**AERONAUTICAL CHARTING FORUM**  
**Instrument Procedures Group**  
**Meeting 12-01 – April 24, 2012**  
**HISTORY RECORD**

**FAA Control # 12-01-301**

**Subject:** Publishing a Vertical Descent Angle (VDA) with 34:1 Surface Penetrations in the Visual Segment (*Also includes Issue 13-01-309 - LP Procedure Cancelled Because of VDA Not Being Charted*).

**Subject: LP Procedure Cancelled Because of VDA Not Being Charted**

**ORDER 8260.3, VOLUME 1, VISUAL PORTION OF FINAL  
PENETRATIONS:**

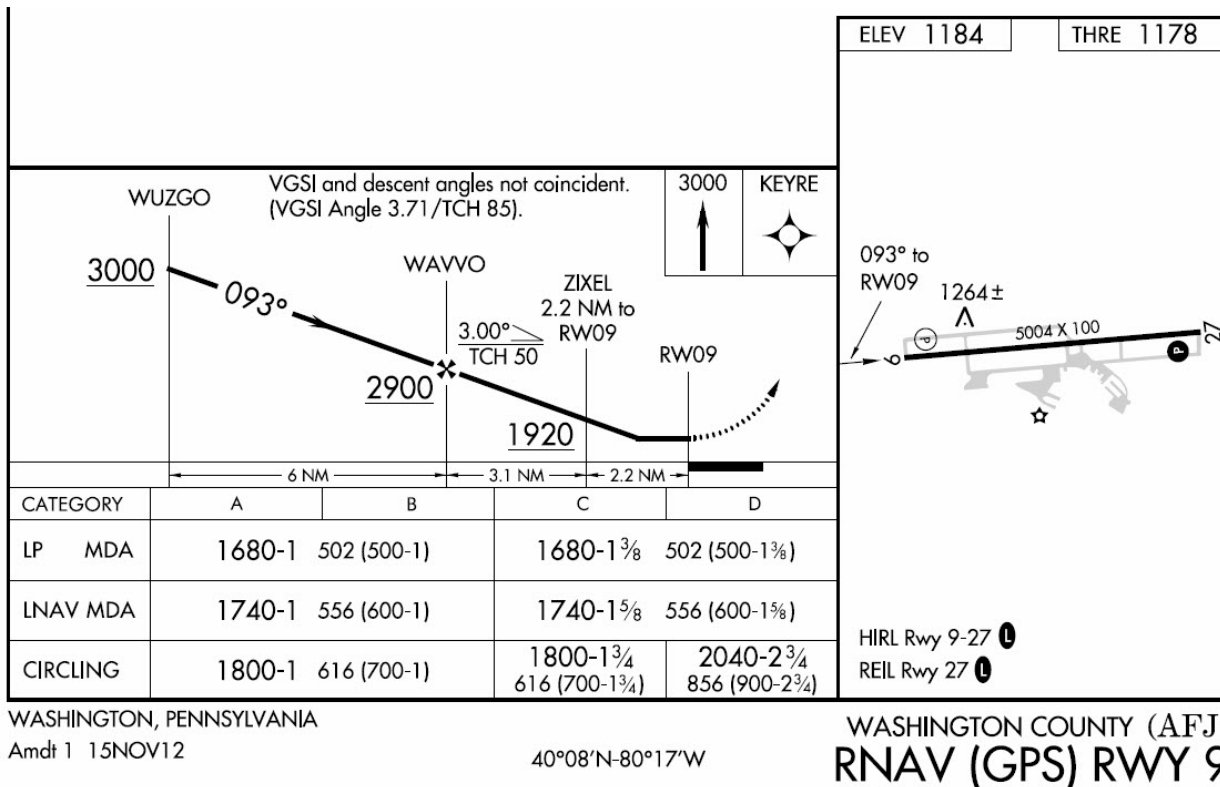
*I called the Quality Advisor involved in the discussion to make sure I understood what was going on. He confirmed that the LP could not be published because it could not be coded with a VDA of 0 (zero). He indicated that the 0 was required to prevent advisory vertical guidance on the procedure.*

*I have several issues with this. The purpose for LP procedures is to provide a lower MDA than permitted by the LNAV where the smaller OCS footprint allows. It is only used when a vertically guided procedure isn't appropriate for the runway. Although a Constant Angle Non Precision Approach (CANPA) may be desirable, it is not always available as an option on all NPA procedures. The advisory glidepath provided by some manufacturers' GPS units is only permitted to be used during the descent to the MDA and not below it. It is my understanding that regardless whether a VDA is published or not, advisory vertical guidance may be provided, in that if the 8260 doesn't provide the data for the advisory glidepath, the manufacturer may calculate one. Therefore, setting the VDA to 0 in the database doesn't necessarily eliminate the advisory glidepath from the database. Because of the coding issue described by the Quality Advisor, the LP procedure is eliminated. It is ironic that the unintended consequence is that the LNAV will end up with an advisory glidepath, but if it is coded in the database it will not generate advisory guidance, at least in the Garmin units. This is because, the LP procedure in the Garmin units don't support advisory vertical guidance under any circumstance whenever LP is the highest service level coded for the approach, regardless if the integrity at the time of the approach supports LP or LNAV. My understanding of the ACF issue dealing with VDA was only to affect whether or not the VDA would appear on the chart and there was to be a note added to the effect "Descent Angle NA". This situation ends up being a 'catch 22', if the runway doesn't qualify for vertical guidance, and flight testing indicates that CANPA is not an option, it doesn't qualify for LP, and when a LP is coded it doesn't have advisory vertical guidance, but if only a LNAV is coded, it does have advisory vertical guidance.*

**Recommendations:** *The database coding of LP procedures should be permitted even when the VDA is not charted. Being able to fly a procedure with CANPA should not be a requirement for a NPA.*
